YAMHILL COUNTY
2026 NORTH VALLEY ROAD FULL DEPTH REPAIR
& CULVERT REPLACEMENT PROJECT
ADDENDUM #2

DATE: January 28, 2026
TO: All Interested Persons
FROM: Greg Haffner, Public Works Engineering Manager

Replace Sheets C-1 and C-4 with the attached Sheets.

C-1

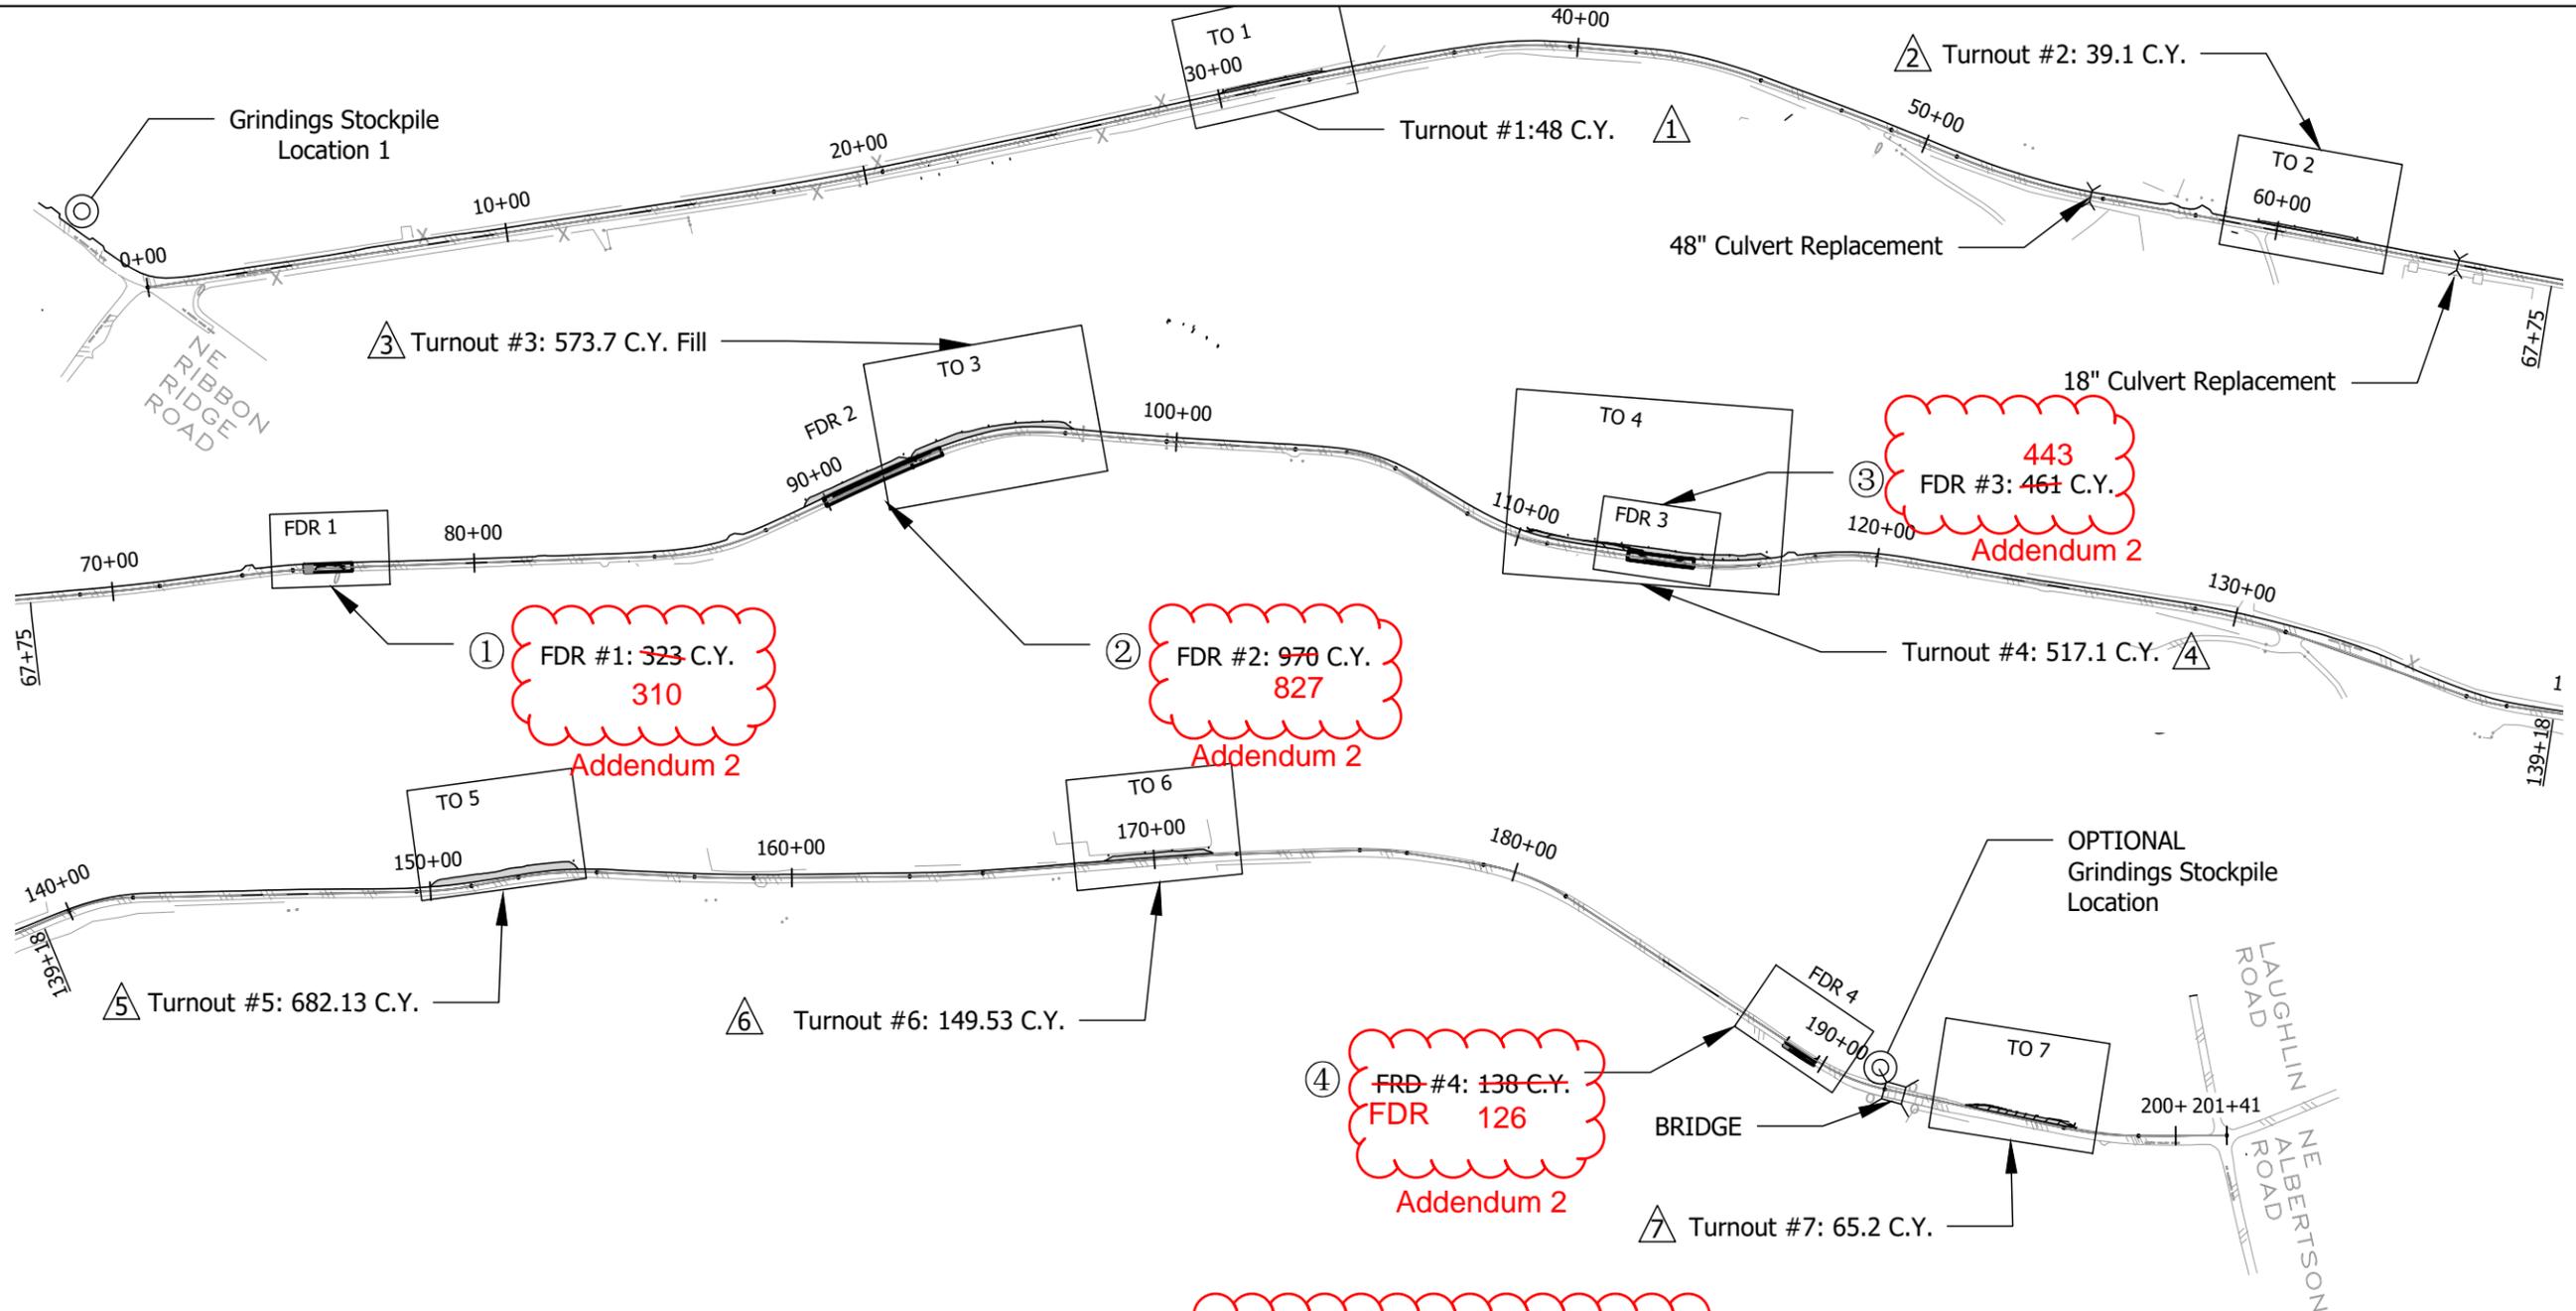
C-1 adds Survey note and revises Sheet table
